URBAN DESIGN COMMISSION APPLICATION

Title: CAPITAL VIEW APARTMENTS

CAPITOL VIEW AT OAK PARK

Letter of Intent

C200

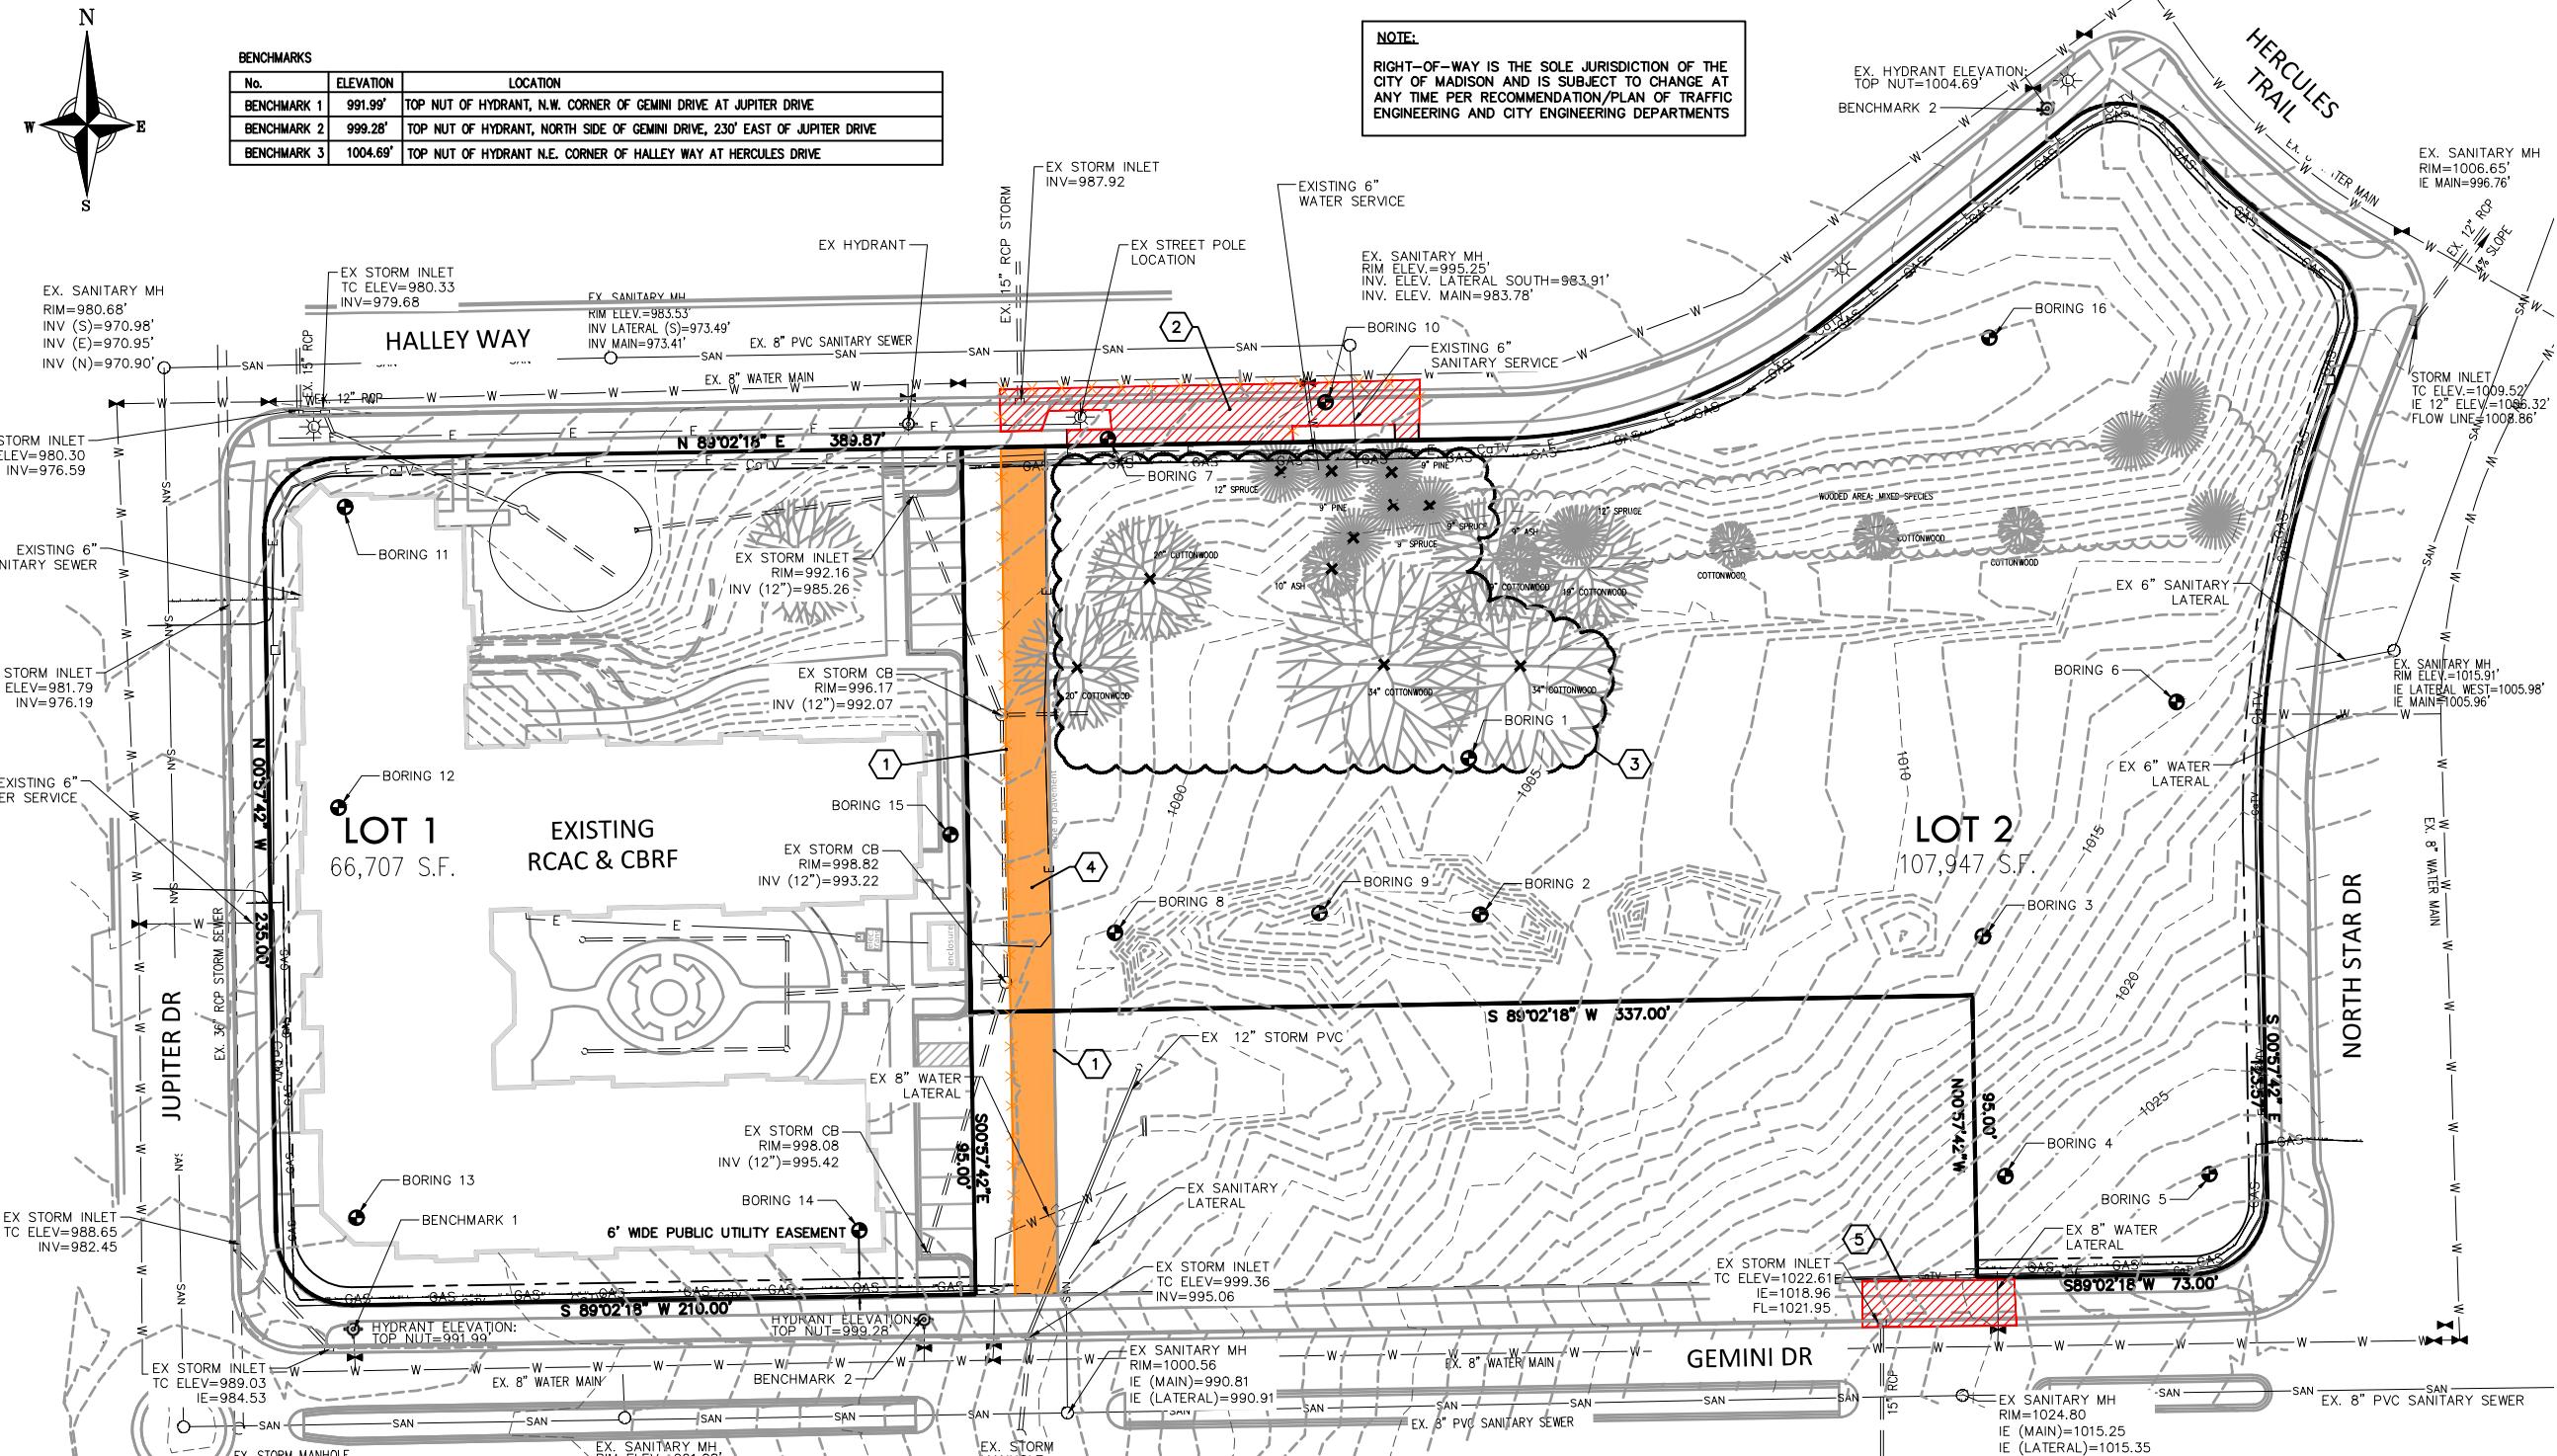
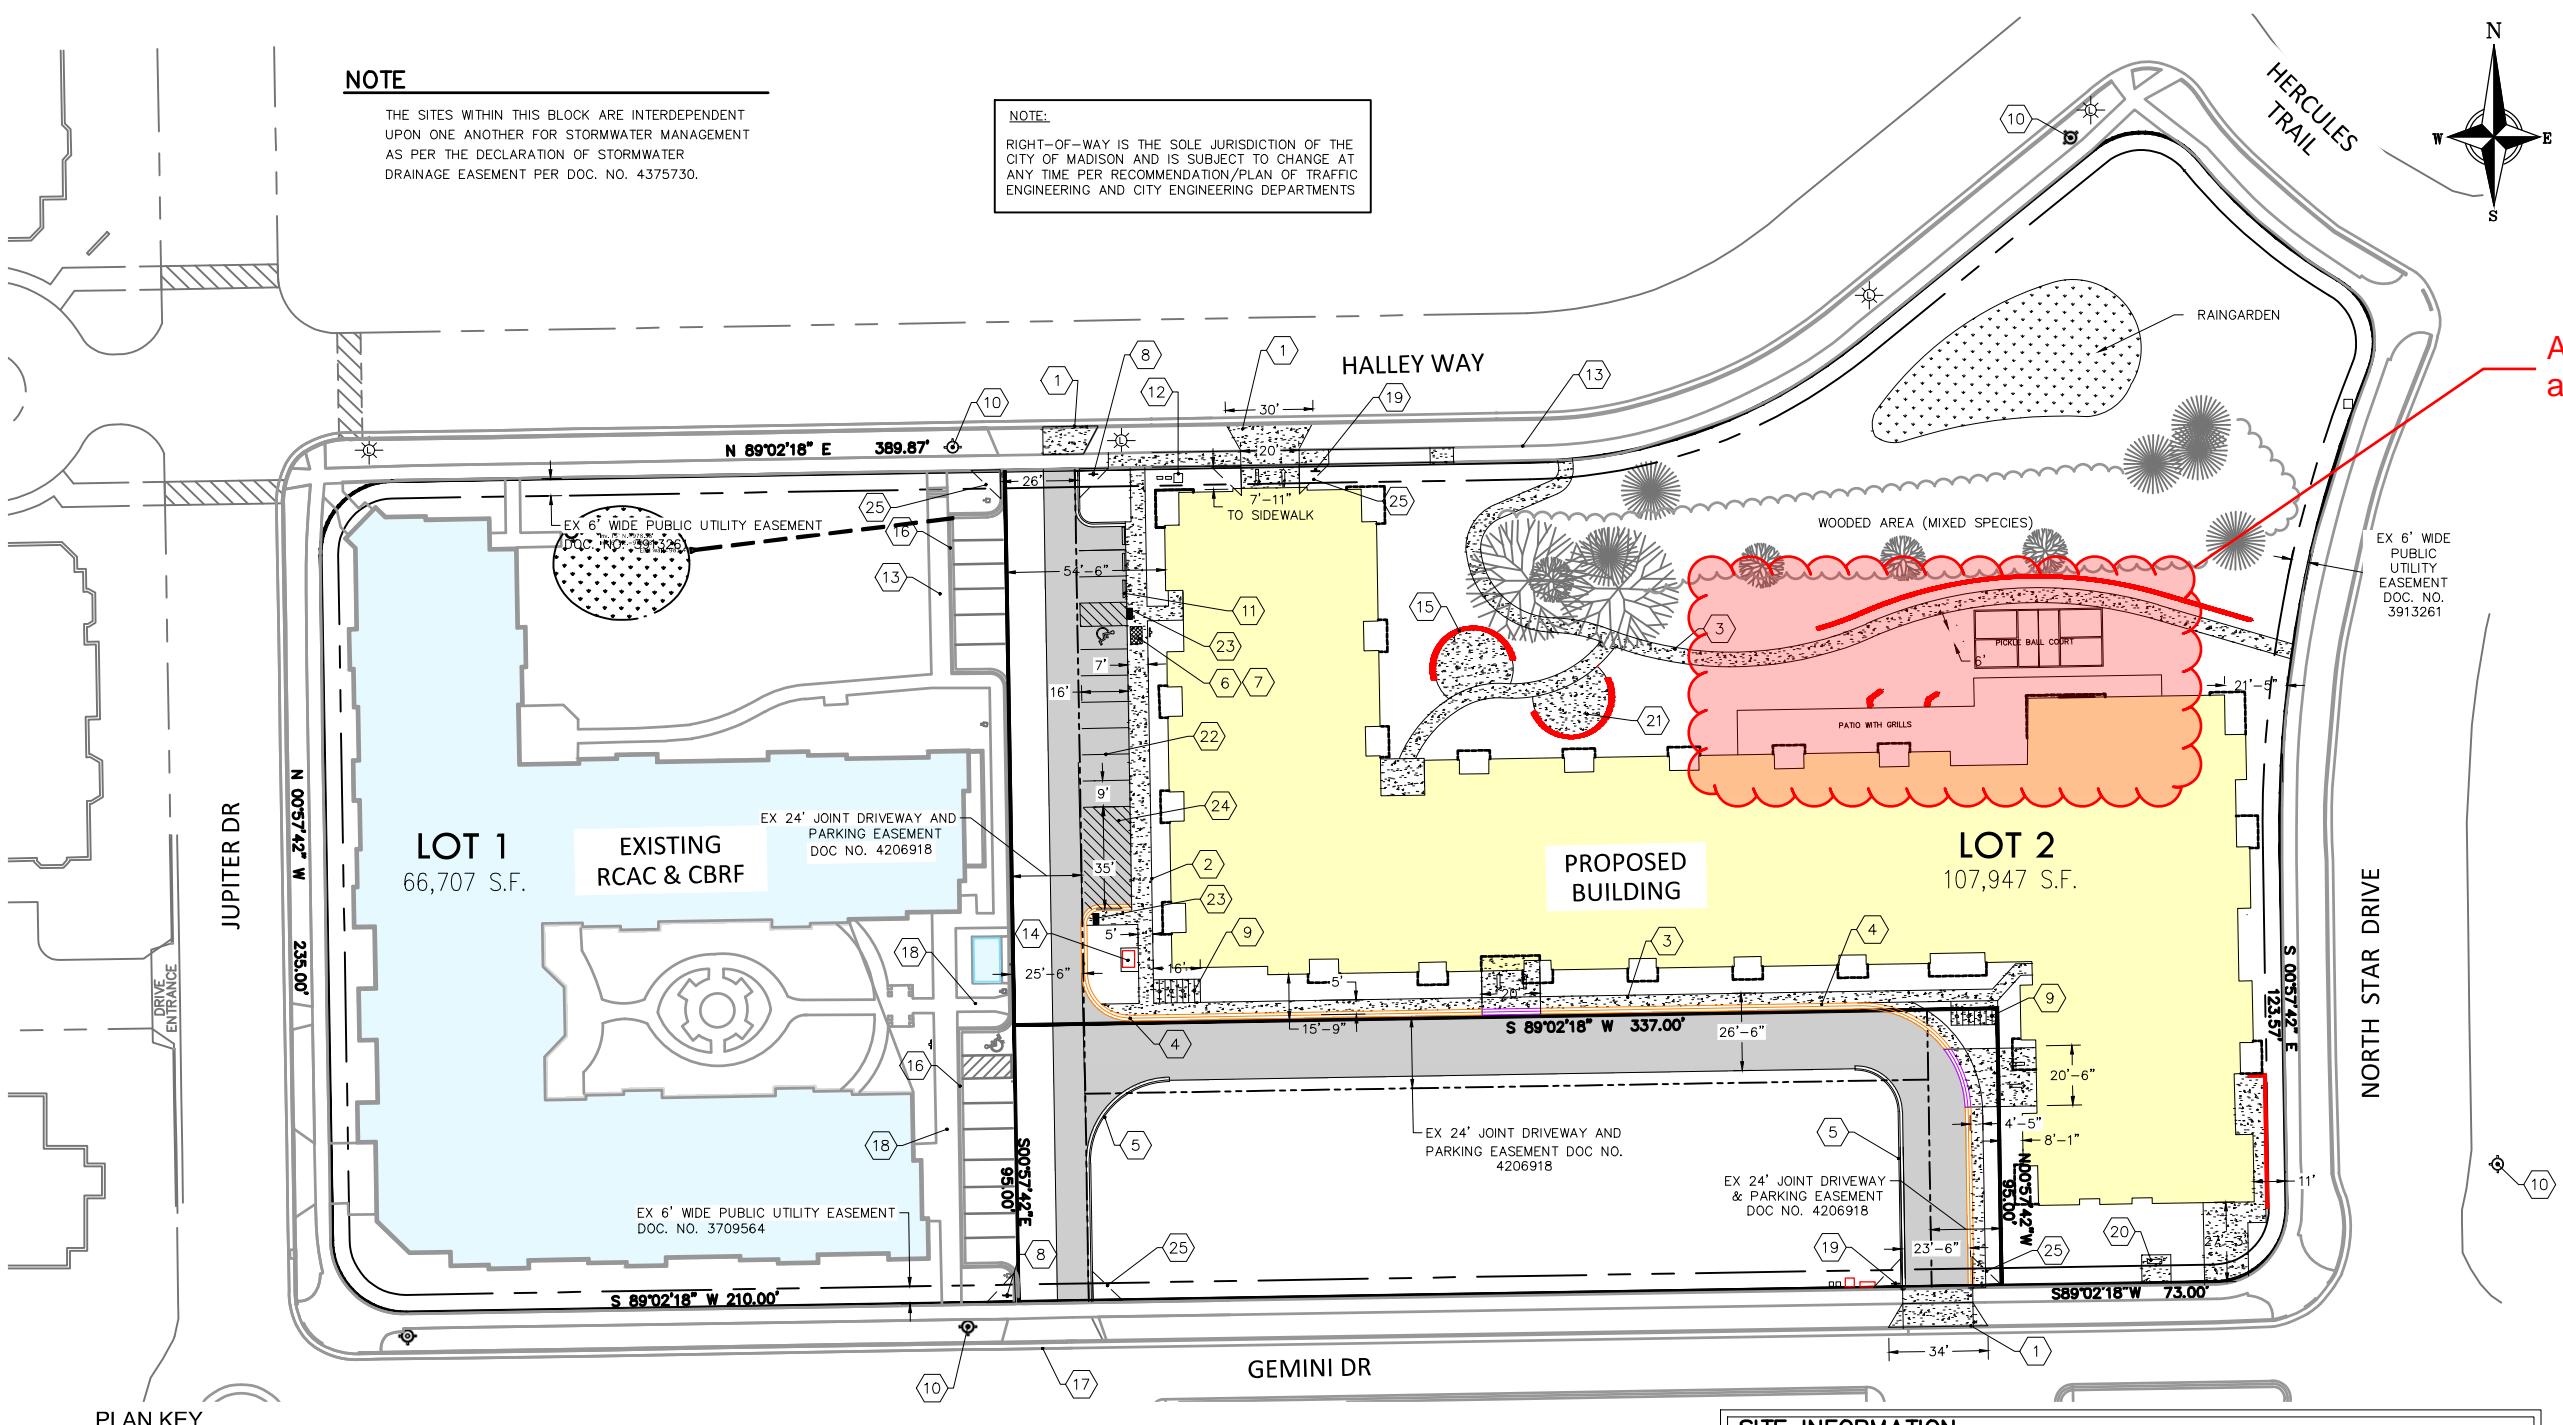
Added outdoor amenity space

L100

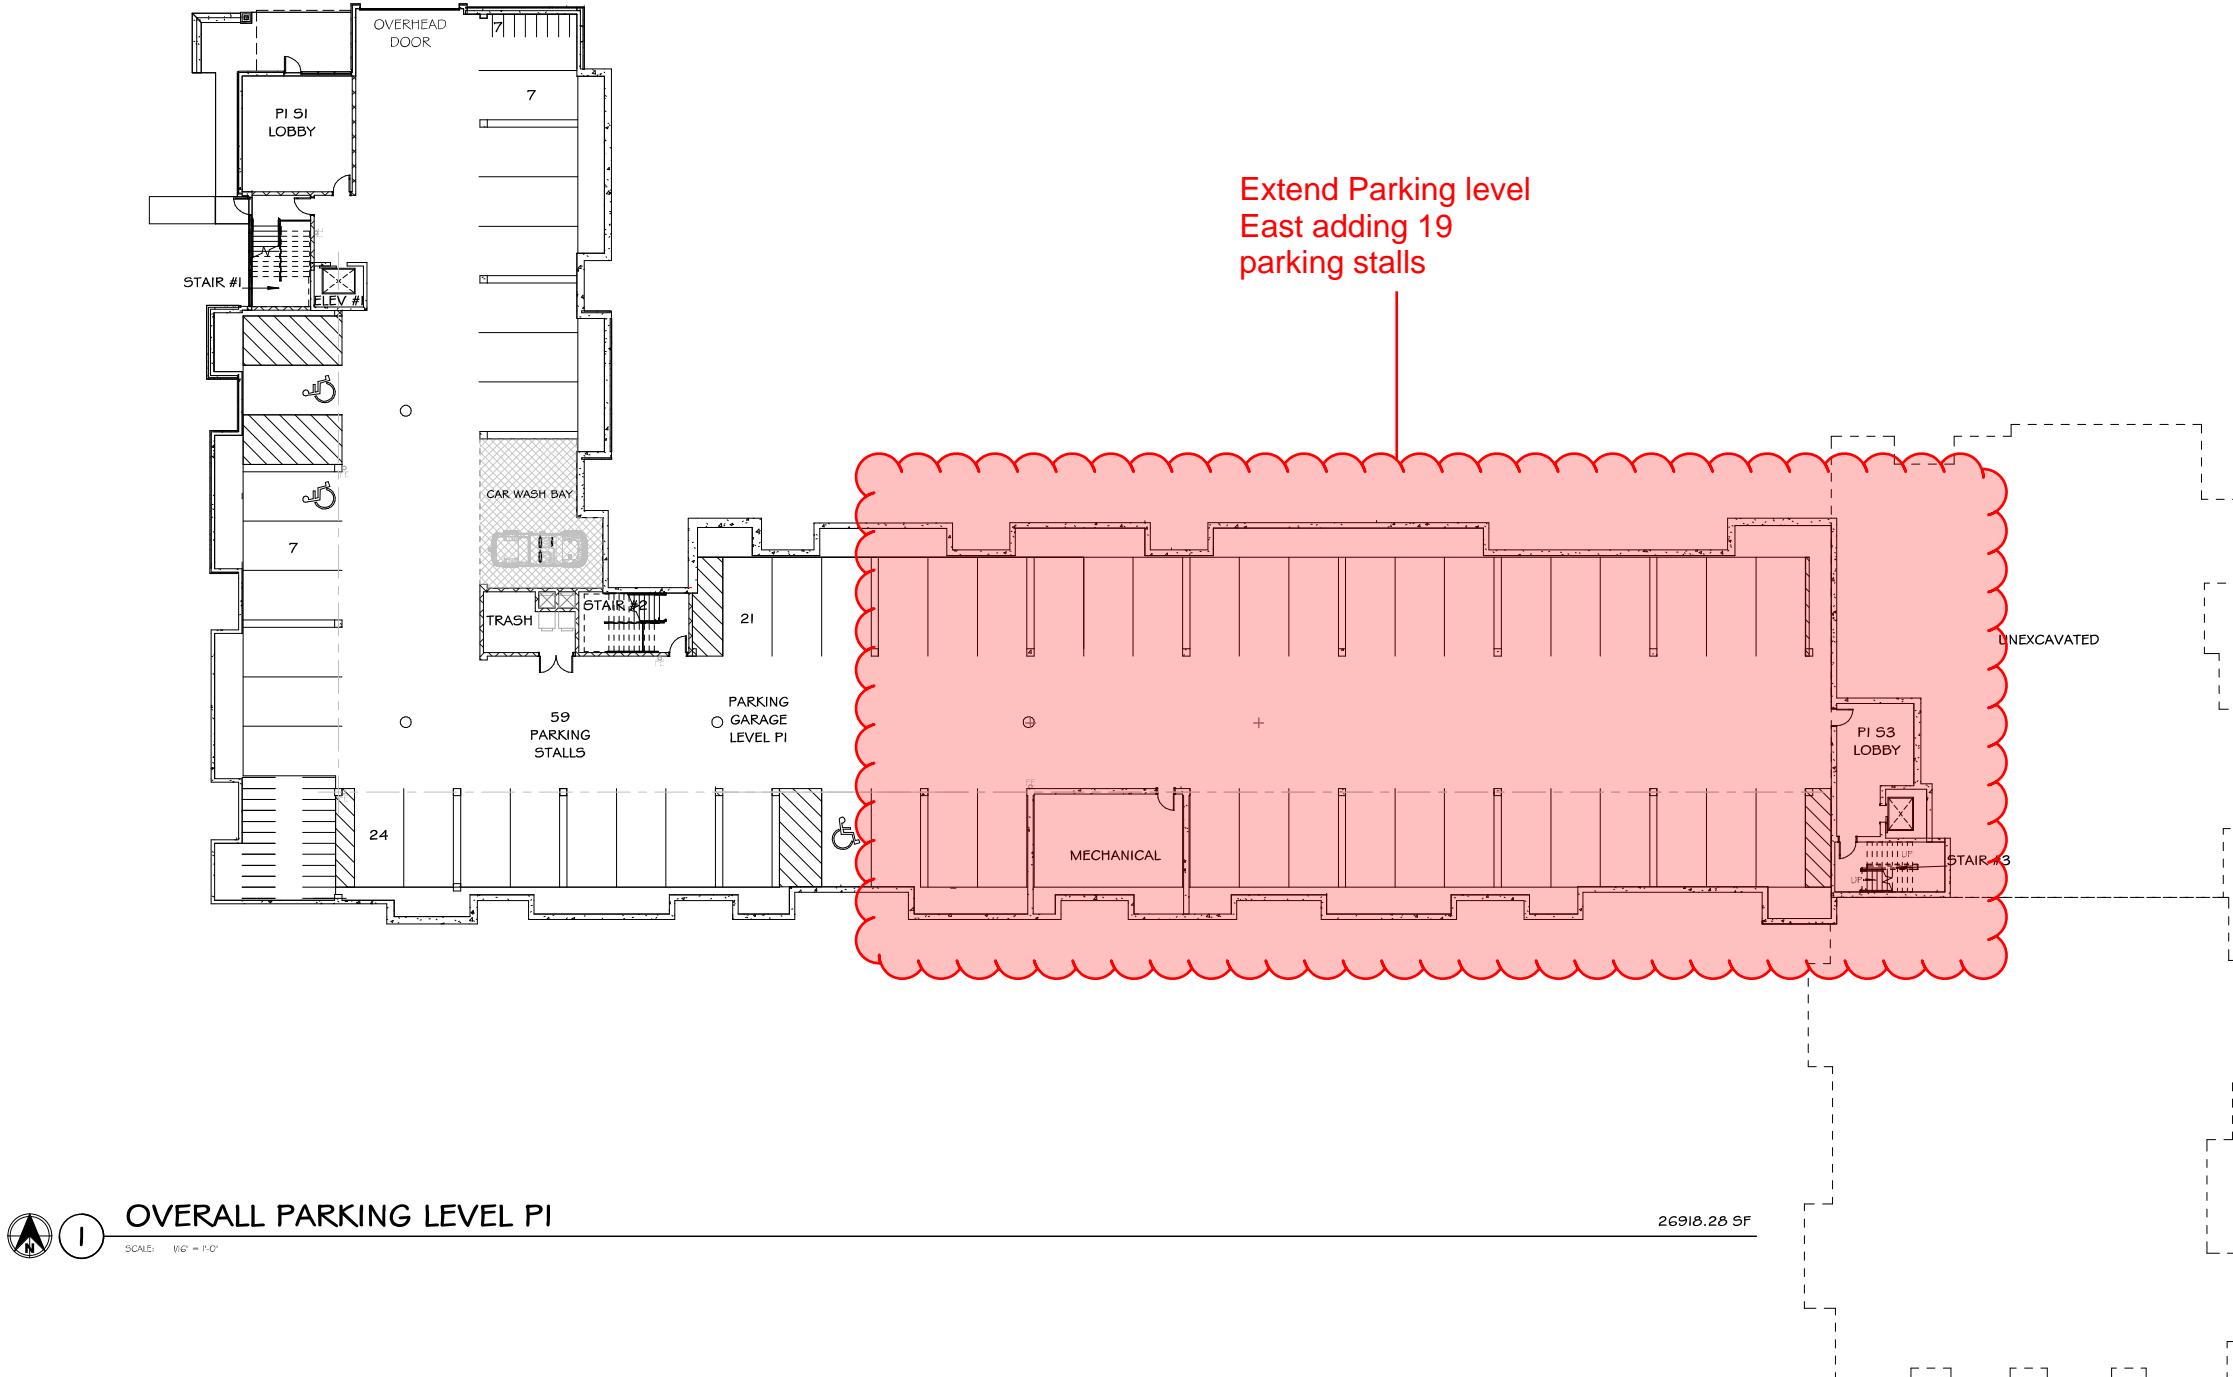
Reconfigure
foundation planting
and landscaping
around outdoor
amenity space
